KUCHING PORT AUTHORITY

KUCHING PORT EXPANSION PROJECT

SUMMARY REPORT

JAPAN PORT CONSULTANTS, LTD.

Fig - A PLAN OF REVETMENT

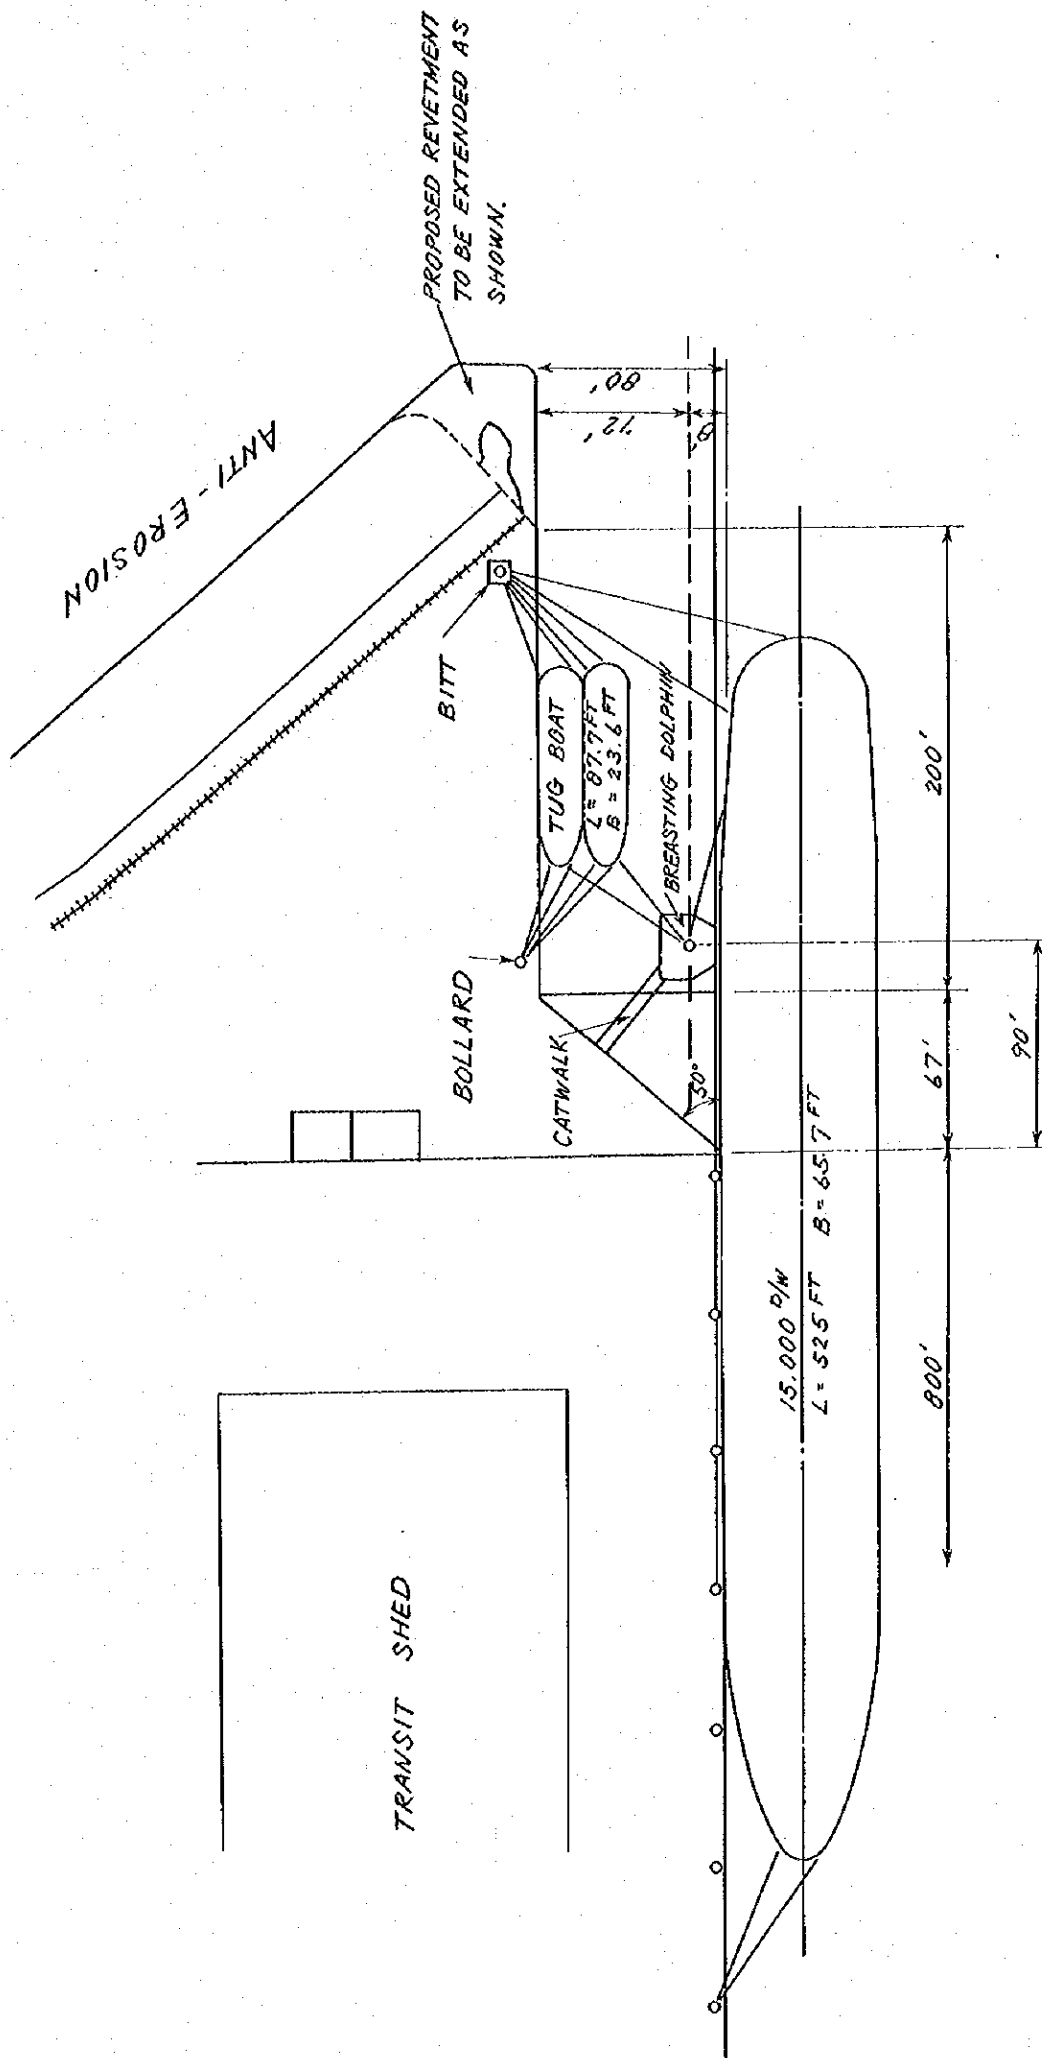
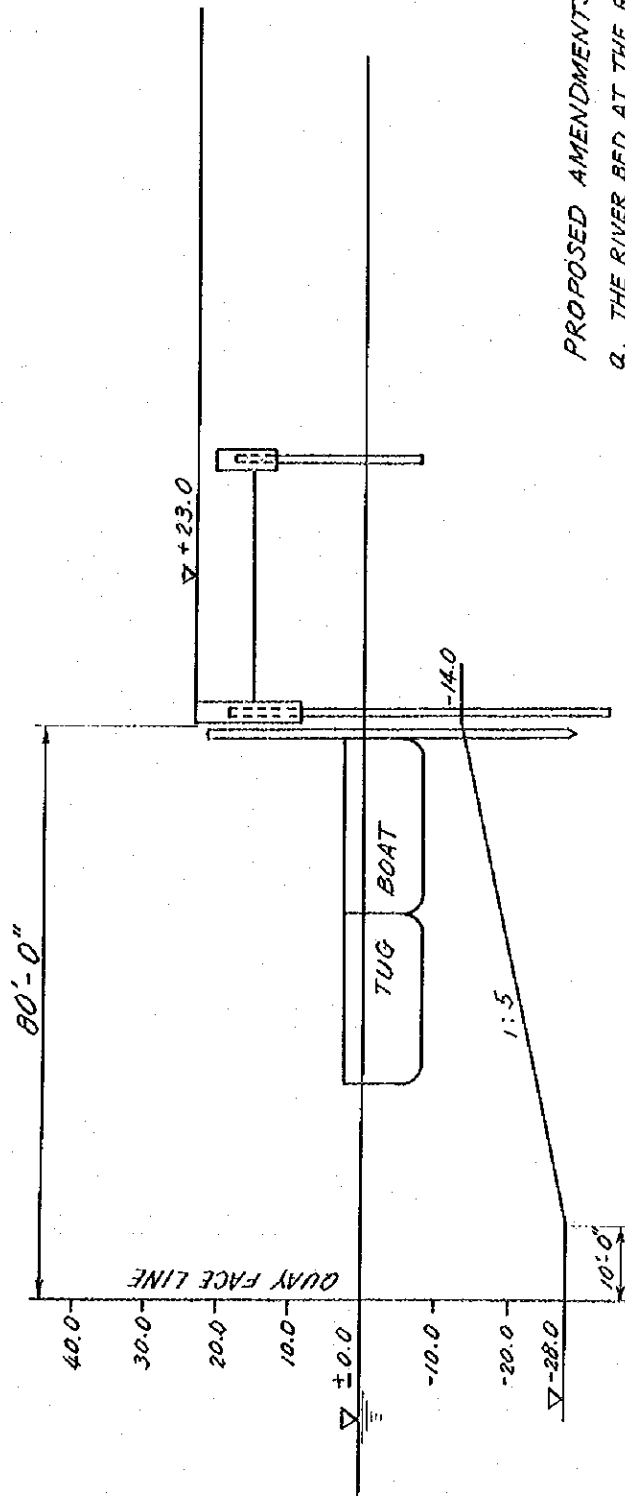
PROPOSED AMENDMENTS:
